Item ID: D3290-3

Item Name: Window

DART AEROSPACE LTD HAWKESBURY, ONTARIO, CANADA	REV. C
DRAWING NO. D3290	SHEET 1 OF 2
TITLE REPLACEMENT WINDOW ASSEMBLY	SCALE 1:5

DRAWING NO. D3290	TITLE REPLACEMENT WINDOW ASSEMBLY	REV. C	DART AEROSPACE LTD ENGINEERING ORDER		D.E.O. NO. D3290-C-1	SHEET NO. SHEET 1 OF 1	SCALE NTS
DRAWN <i>qp</i>	CHECKED <i>l</i>	MFG. APPR. <i>E</i>	APPROVED <i>MP</i>		DE APPR. <i>#</i>		
DATE 09.09.18	DATE 09.09.18	DATE 09.09.18	DATE 09/09/21		DATE 09/09/21

D3290-1 FRAME

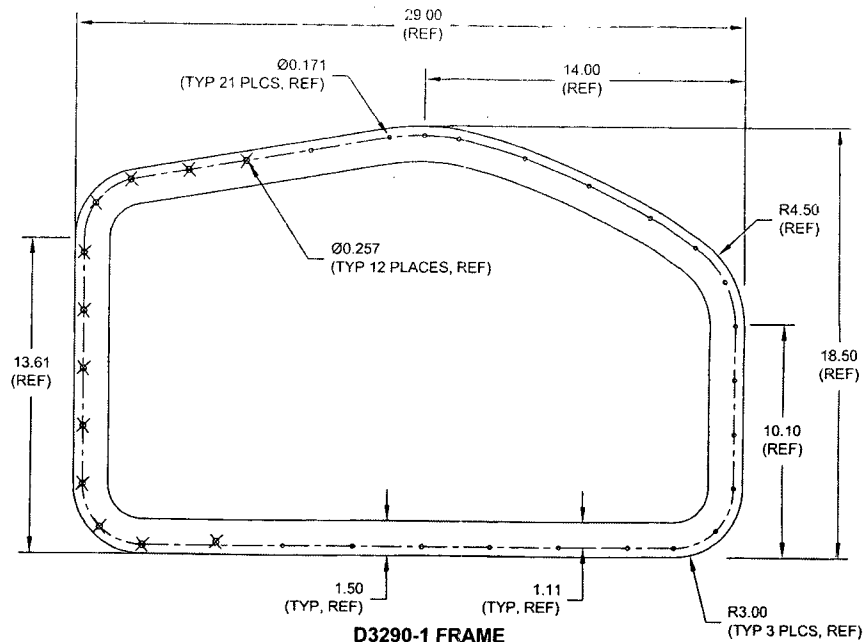
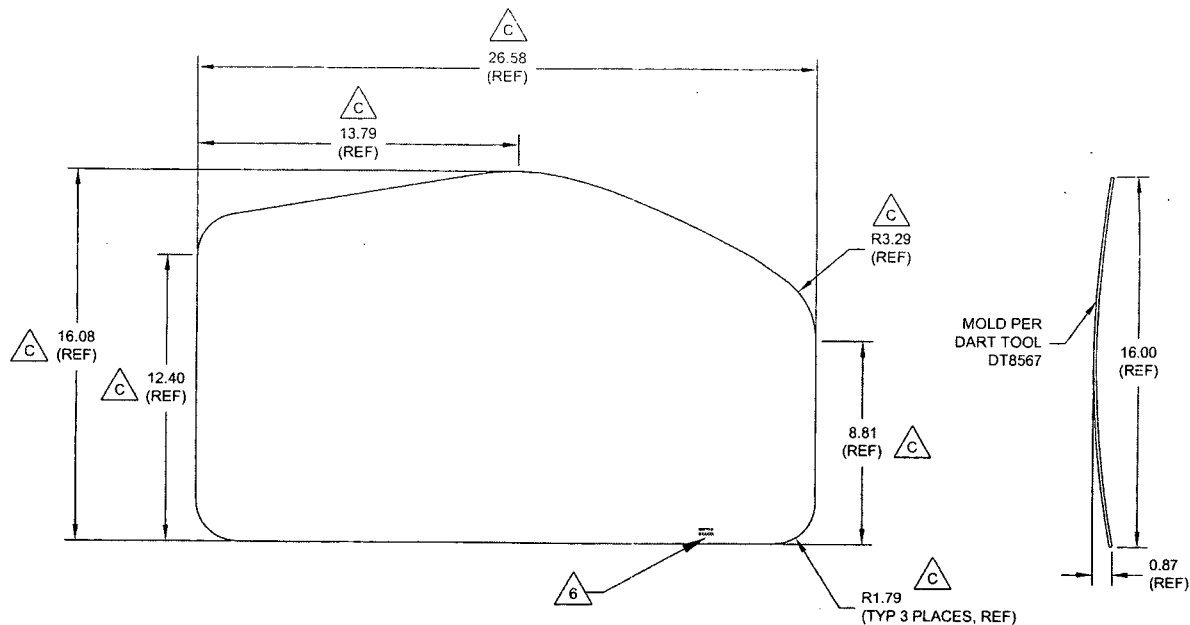
PURPOSE:

CHANGE MATERIAL THICKNESS OF D3290-1 FRAME TO 0.063 FROM 0.040. REF PAR 09-033.

MATERIAL CALL-OUT OF D3290-1 FRAME ON SHEET 1 IS AMENDED AS FOLLOWS:

- 1) MATERIAL: 6061-T6 (OR 6061-T62) ALUMINUM SHEET ~~0.040 THICK~~ 0.063 THICK (REPLACE)
 PER AMS-QQ-A-250/11 OR AMS 4025 OR AMS 4027
~~(REF. DART SPEC. M6061T6S.040)~~ REF. DART SPEC. M6061T6S.063 (REPLACE)
 OR
 5052-H32 ALUMINUM SHEET ~~0.040 THICK~~ 0.063 THICK (REPLACE)
 PER AMS-QQ-A-250/8 OR AMS 4016
~~(REF. DART SPEC. M5052H32S.040)~~ REF. DART SPEC. M5052H32S.063 (REPLACE)
